APPLICATION FOR PERMIT
DEPARTMENT OF BUILDING INSPECTIONS SERVICE
ELECTRICAL INSTALLATIONS

PERMIT # 2502 CITY OF PORTLAND **NO. 2** BUILDING PERMIT APPLICATION MAP # _____ LOT# _____

PORTLAND HIGH SCHOOL MASONRY WALL REPAIRS AT PENETRATIONS
GENERAL NOTES SHEET W

PORTLAND HIGH SCHOOL MASONRY WALL REPAIRS-INSPECTOR NOTES

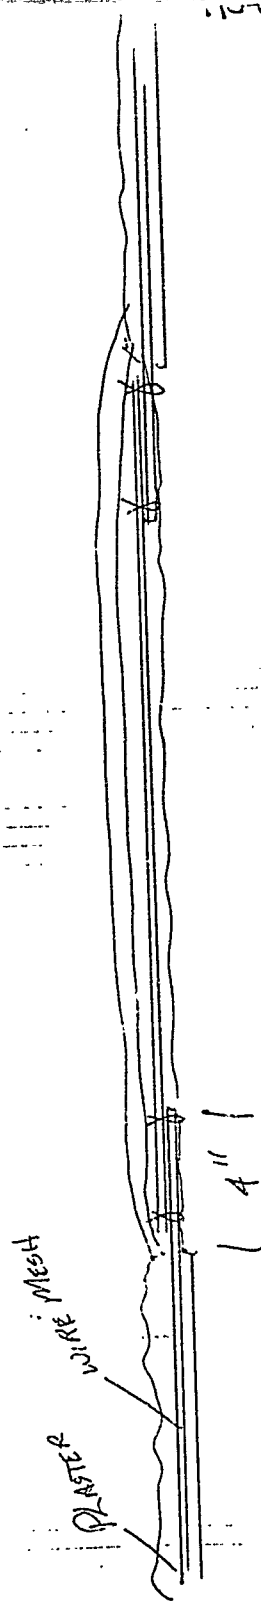
- A. Verify the presence or absence of a concentrated load by locating beams bearing on the wall. Metal detector may be required.
- B. Make a sketch of the openings in the wall of the room above to verify that concentrated loads do NOT exist over opening to be repaired and that the brickwork over opening has adequate arching.
- C. If a concentrated load (such as a beam or a column of brickwork) is present over the opening, develop a design to accommodate the site specific conditions. The exception is condition 2. A.

- A. If a concentrated load is present or there is inadequate arching action above, fill the full thickness and extent of the opening with concrete or solid brick units. (Specify Detail W1)
Pipes ARE Permitted
- B. If concentrated load is NOT present and the opening width is less than 24 in., fill the extent of the opening with 4 in. of concrete or solid brick units. (Specify Detail W2) If the opening is less than 6 in., firestop material can be used to fill the full thickness and extent of the opening.
- C. If concentrated load is NOT present and the opening width is greater than 24 in., fill the full thickness and extent of the opening with solid brick units. (Specify Detail W3)

- A. Penetrations from 0 in. to 24 in. wide: Fill the full thickness of the opening in the brickwork to the extent of the penetration with concrete or solid brick units and install containment for the existing brickwork over the penetration. Verify that the brickwork above the

penetration is sound. (Specify Detail W4) If the brickwork above the penetration is not sound, a lintel shall be installed per detail W5.

- B. Penetrations from 24 in. to 36 in. wide: Install 3/8 in. plate lintel and fill the full thickness of the opening in the brickwork to the extent of the penetration with concrete or solid brick units. (Specify Detail W5)
- C. Penetrations from 36 in. to 48 in. wide: Install 1/2 in. plate lintel and fill the full thickness of the opening in the brickwork to the extent of the penetration with concrete or solid brick units. (Specify Detail W6)
- D. Penetrations greater than 48 in. wide: Develop a design to accommodate site specific conditions.
- E. Opening with non-rigid utilities (BX, communication cables, etc.): Install smallest diameter sleeve which will accommodate the existing utilities. Fill the full thickness to the extent of the sleeve with solid brick units, grout or firestop material as shown. Fill extent of sleeve with firestop material. (Specify Detail W7)
